FMM230 Product Change Notifications

2024.01.22: Modified battery placement within the casing

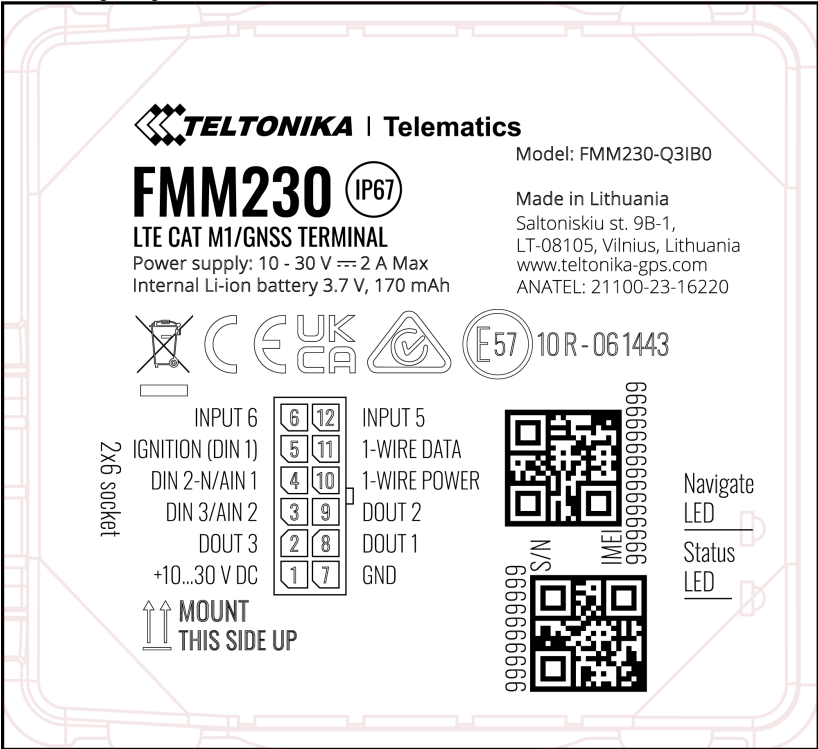
We would like to inform you that starting from January 2024, there will be a small change in the FMM230 devices casing. We have adjusted the battery placement and increased PCB guide height within casing. This modification was essential to enhance our manufacturing process.

Change description	
Change type	Optimizing robotic battery placement process within casing
	The modifications will not impact the place of the battery or PCB within the FMM230 device.
	New Version:

Change reasons	1. Modified battery placement within the casing. 2. PCB guide height increased for easier assembly. 3. Improved manufacturing process.	
Product release date	January, 2024	
Affected products		
Model	Affected order codes	Order code changes
FMM230	FMM230 all codes	Modified battery placement and PCB guide height within the casing.
Change impact		
Risk assessment	During transition period clients might receive devices with previous casing design. The transition period can last from January to February inclusive.	
Suggested implementation plan	No implementation plan is needed.	
Acknowledgement of PCN receipt		
If no feedback is received within two weeks after the issue date of this notification - Teltonika may accept that this change has tactically accepted and can implement the change as indicated above.
